Department of Transportation

Addenda No. 6

SUBJECT: US97: Lava Butte – S. Century Drive Section
The Dalles – California Highway
Deschutes County
Grading, Structures, Paving, Signing & Pavement Markings Project
(Bids to be opened and read May 14, 2009)

SHEET NO. **2B-8**

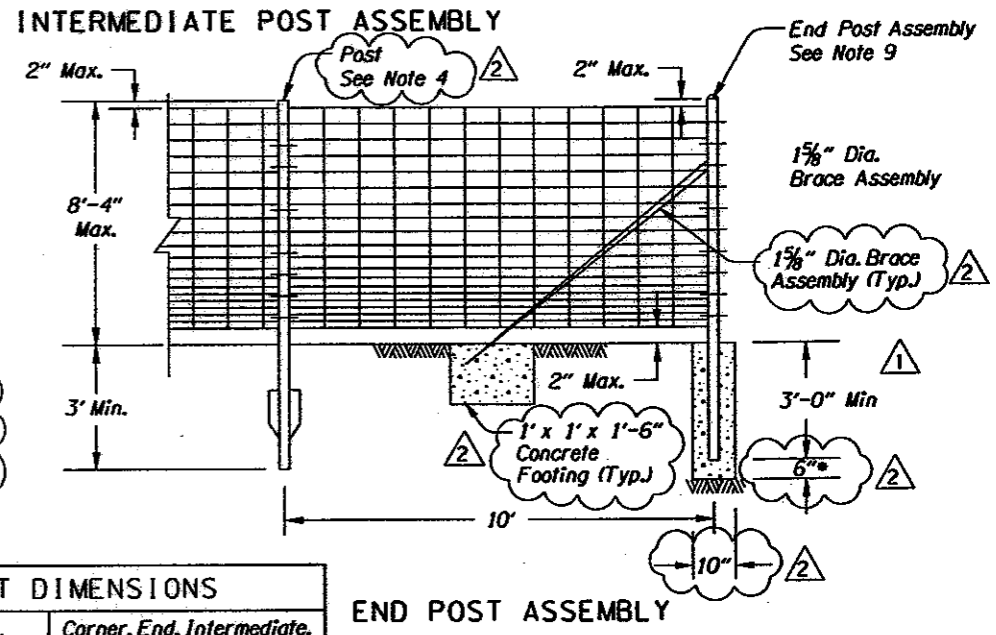
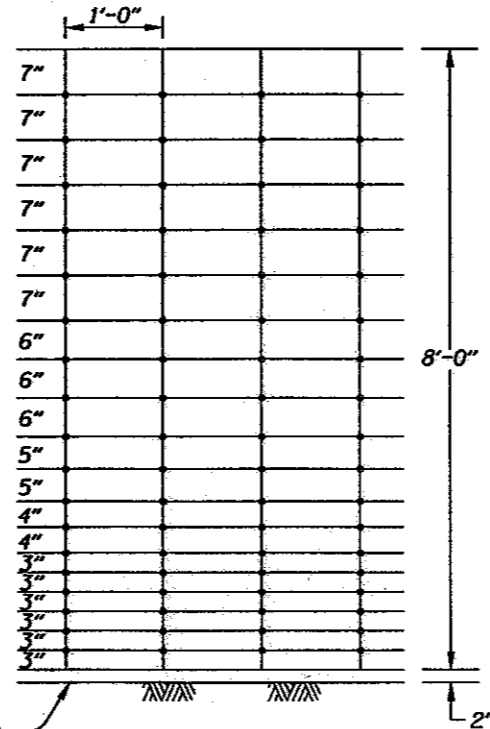
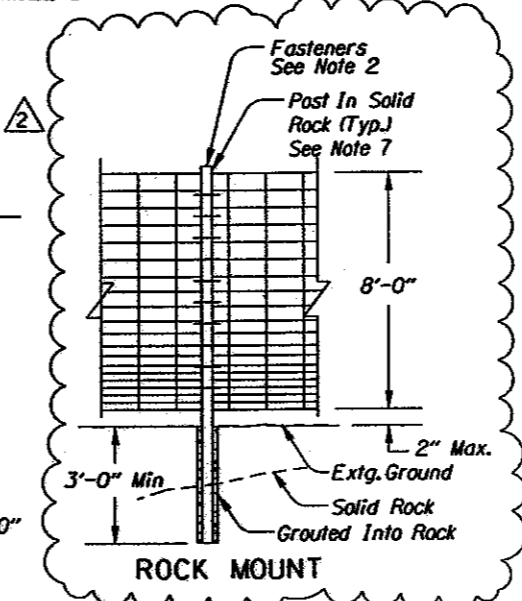
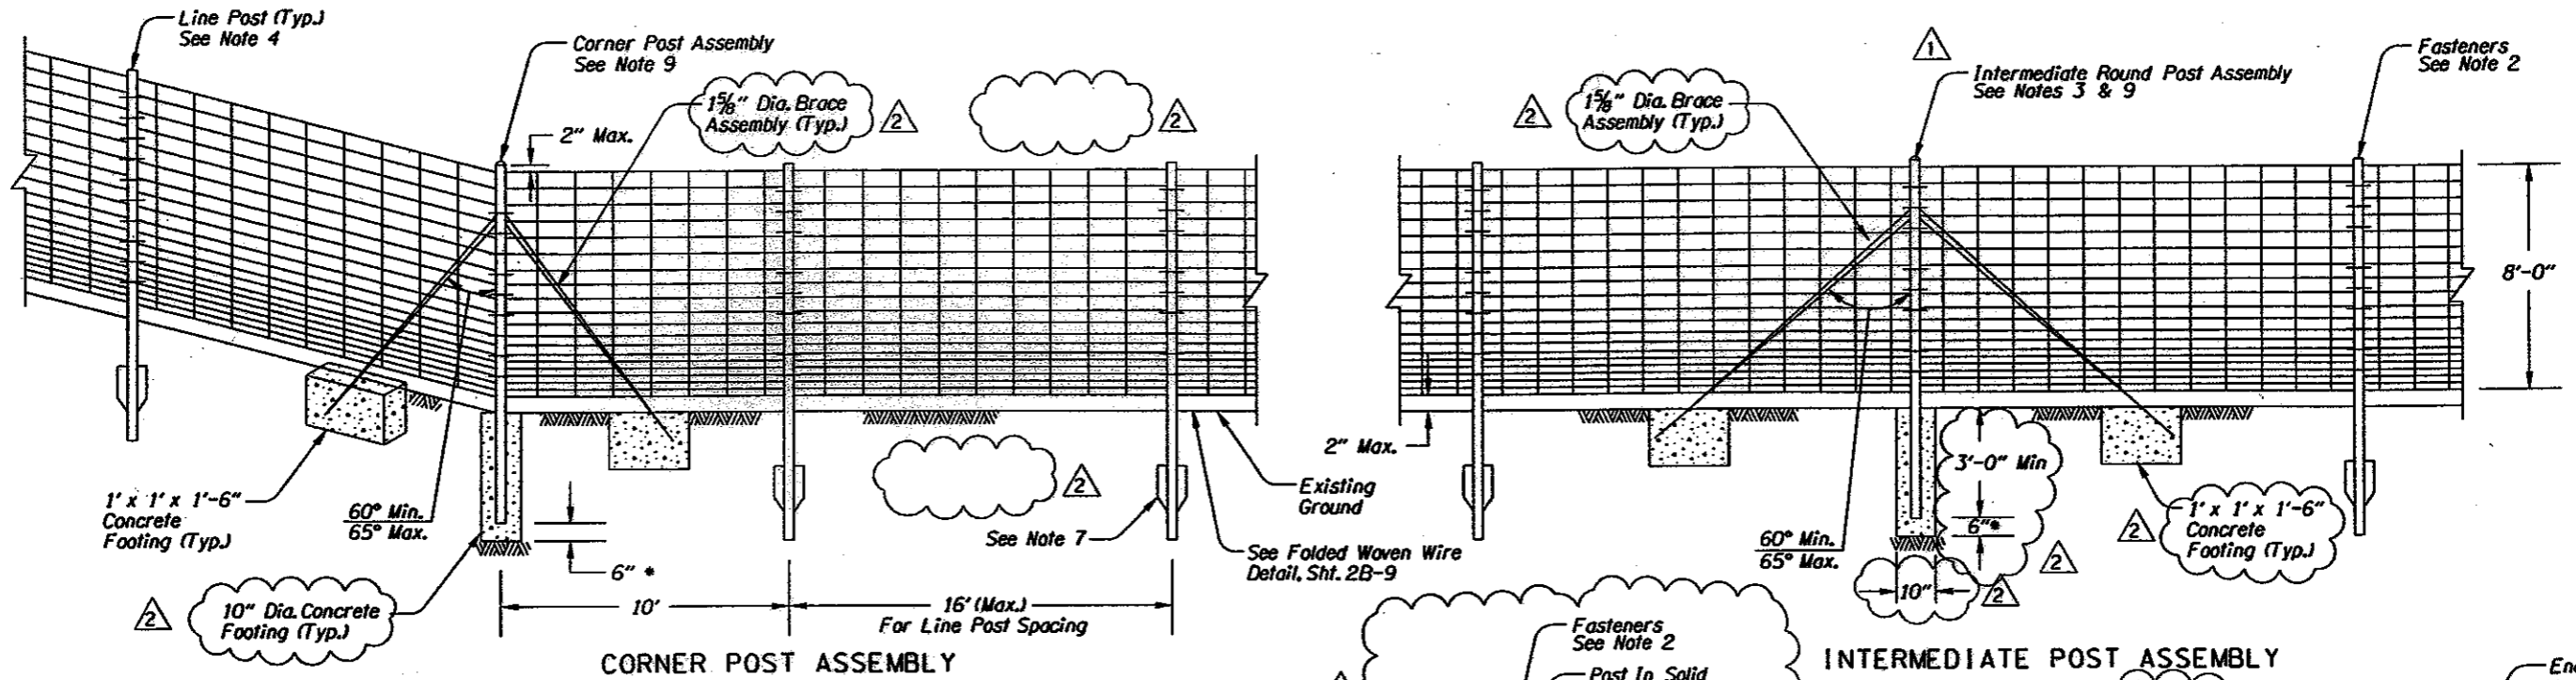
1. Plan sheets 2B-8 and 2B-9 are replaced with revised plan sheets 2B-8 and 2B-9.
